## **Preliminary Site Plan and Special Land Use Review Dexter Township, Michigan**

<b>Applicant:</b>	Corn Man LLC
<b>Project Name:</b>	Cornman Farms Building Additions
<b>Plan Date:</b>	October 31, 2023
<b>Location:</b>	8540 Island Lake Road (D-04-36-400-002)
<b>Zoning:</b>	RR, Rural Residential
<b>Action Requested:</b>	Preliminary Site Plan and Special Land Use Approval
<b>Required Information:</b>	Deficiencies are noted in the sections below.

This is our first review of the preliminary site plan for additional buildings to the Cornman Farms special event facility. The event facility is located on three (3) parcels: D-04-36-400-002 located in Dexter Township, and C-03-31-300-003 and C-31-300-011 located in Webster Township. No improvements are proposed on the Webster Township parcels. For the purposes of this review, the subject site refers to the parcel in Dexter Township, D-04-36-400-002.

A-  
1.00

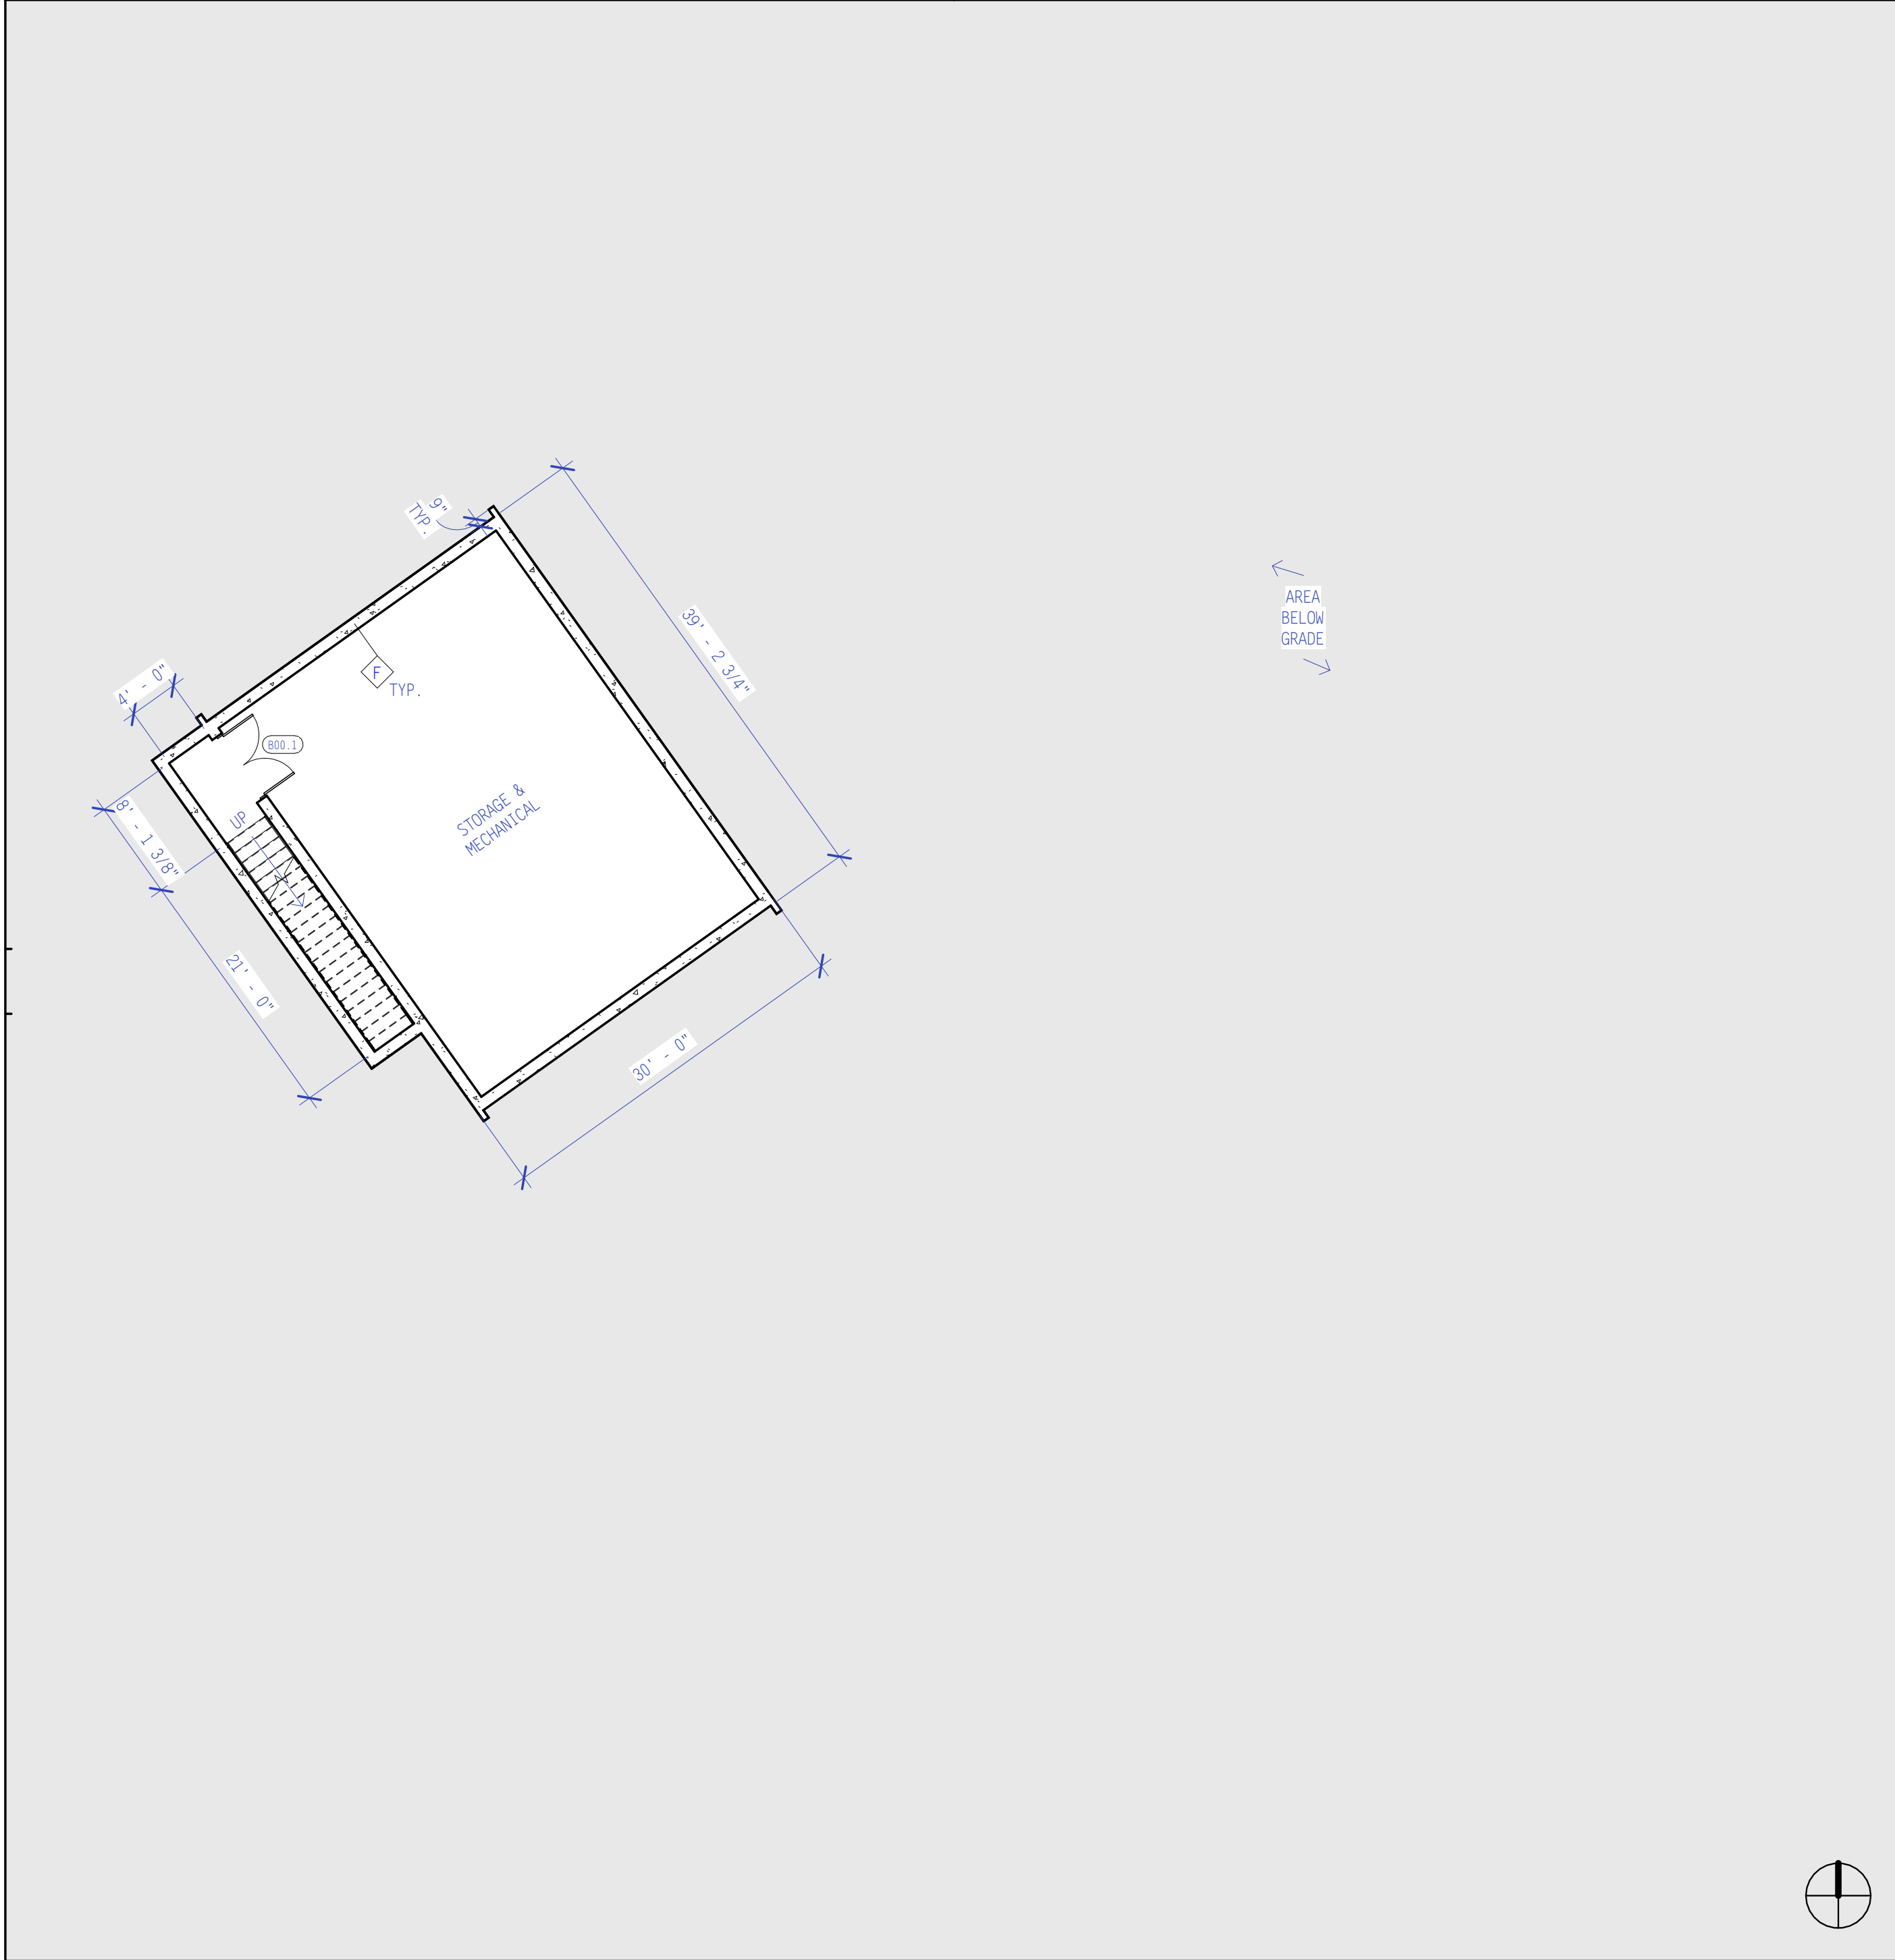
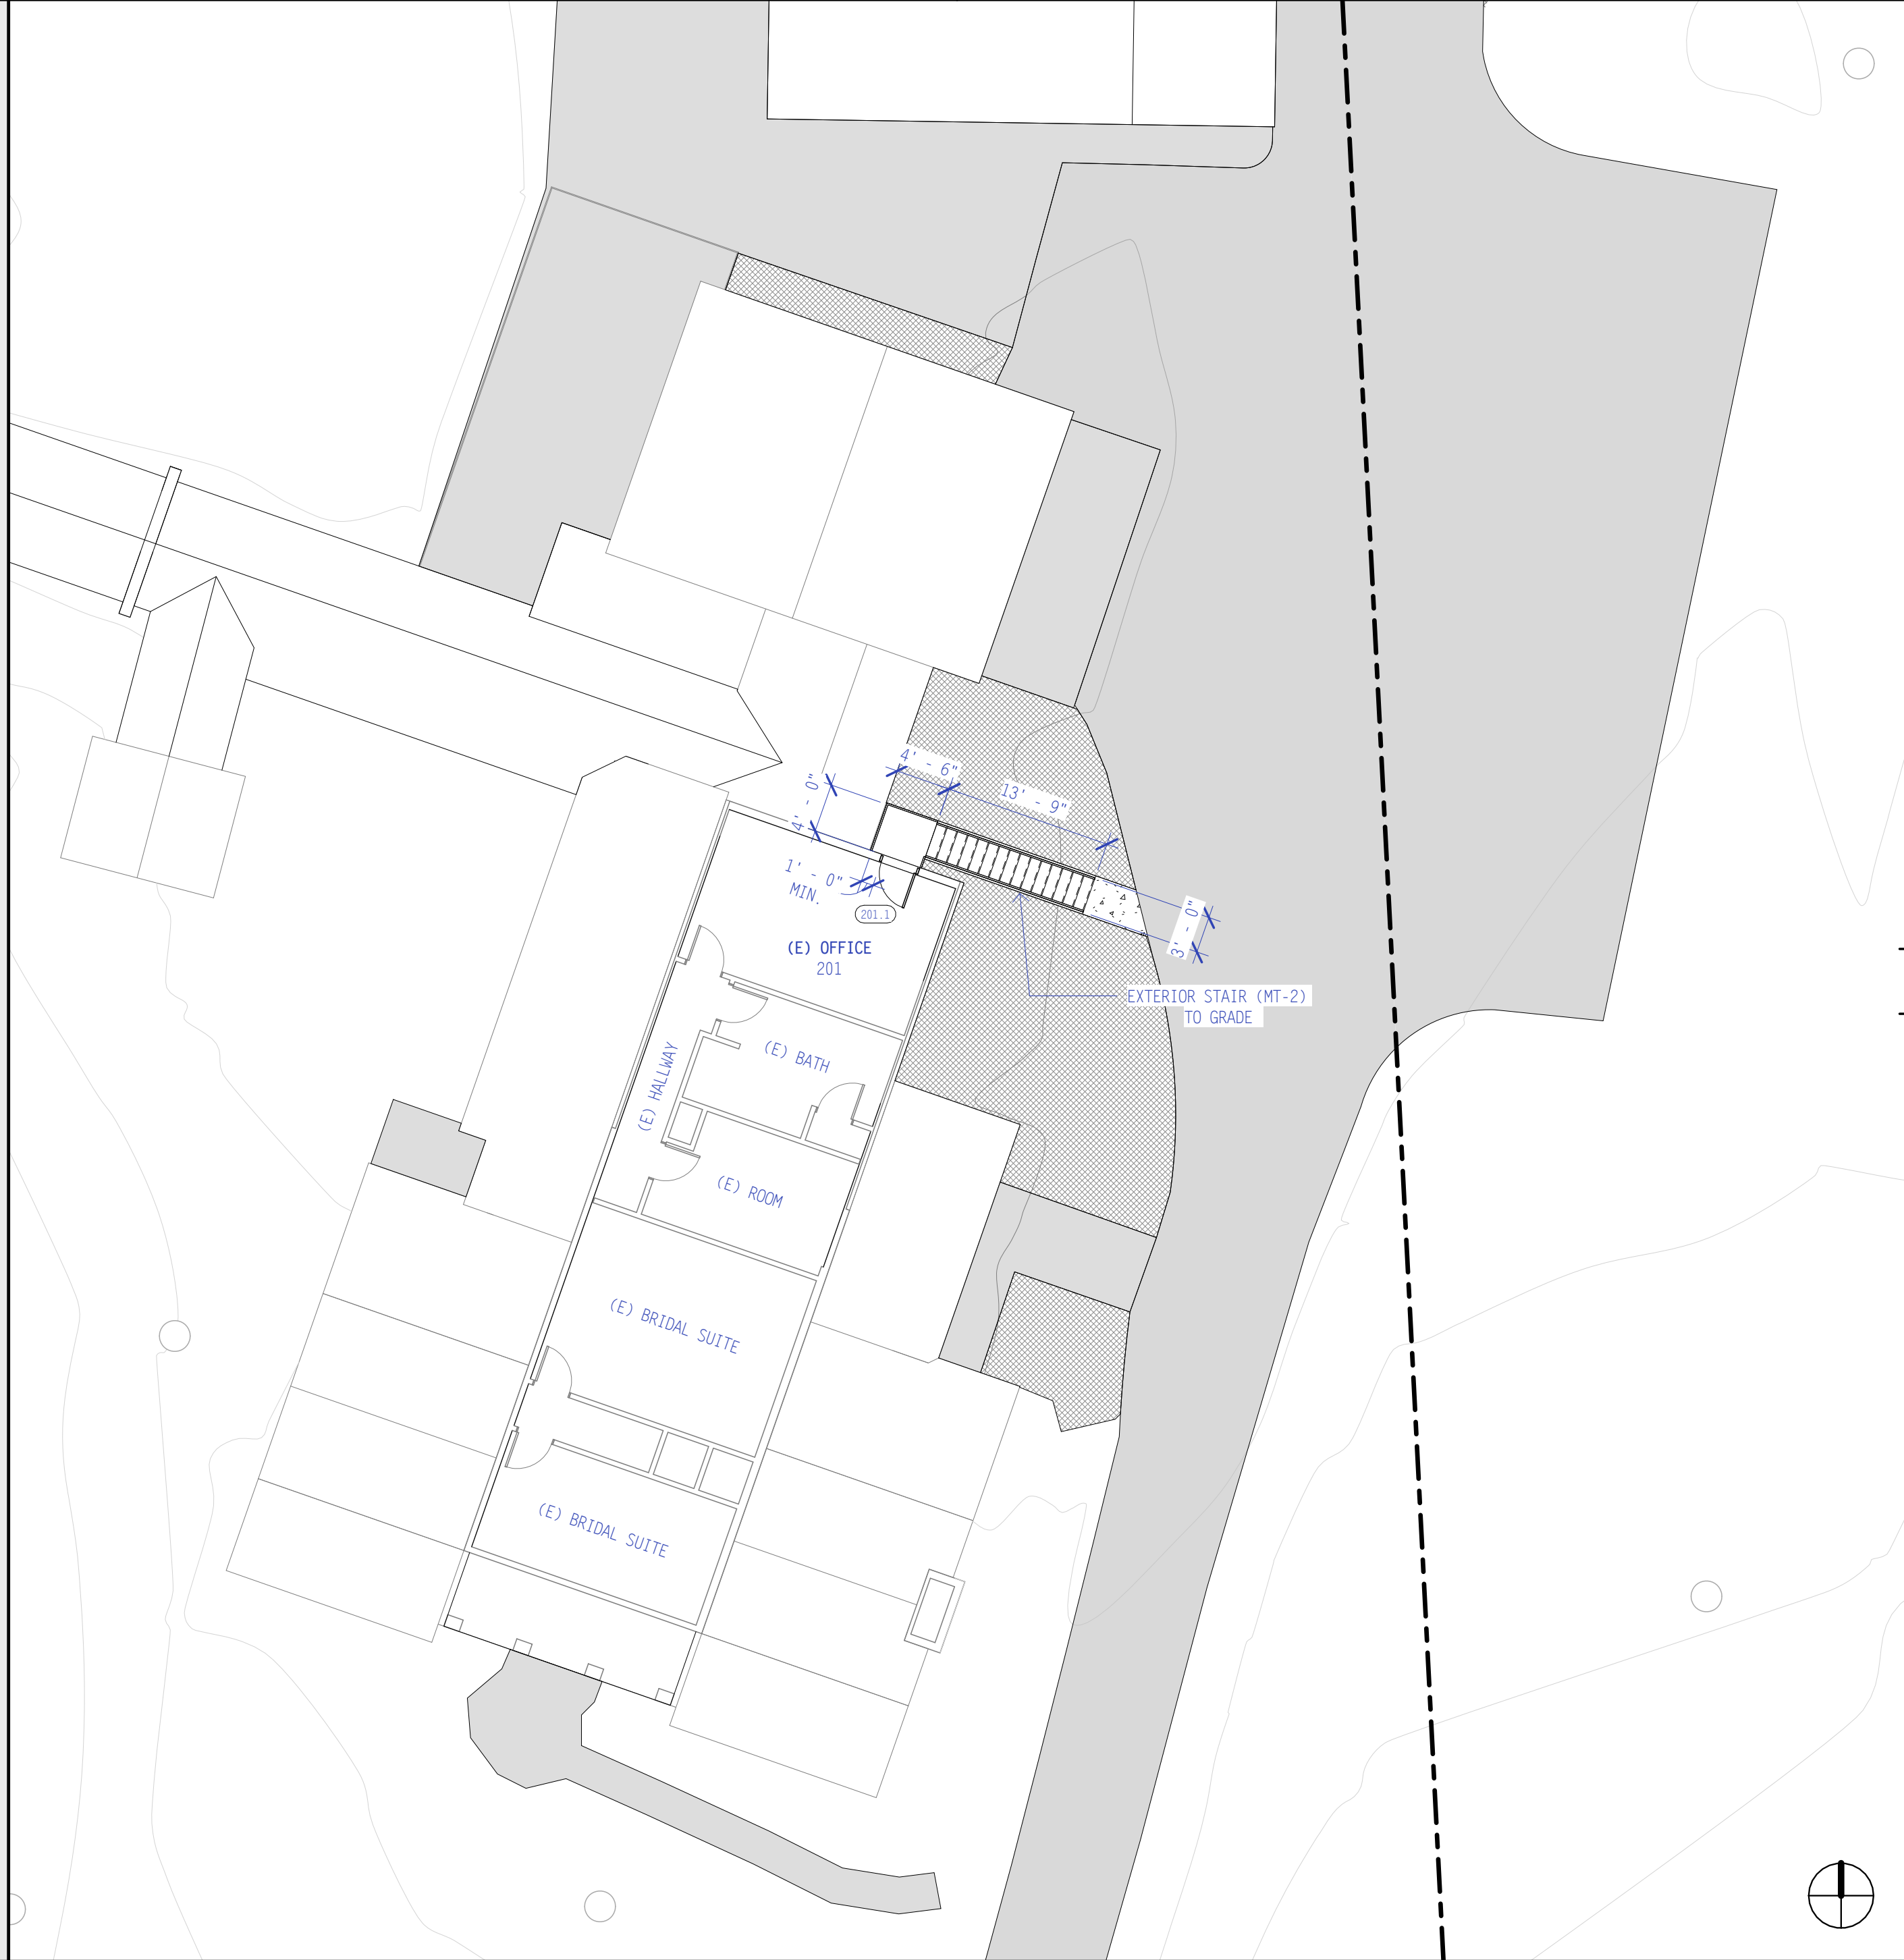
We note that the floor plans on Sheets A-1.00 and A-1.01 show seating in the pavilion and red barn for eighty (80) guests. The applicant should increase the maximum number or revise the floor plans.

**Items to be Addressed:** Clarification from applicant on maximum number of guests.
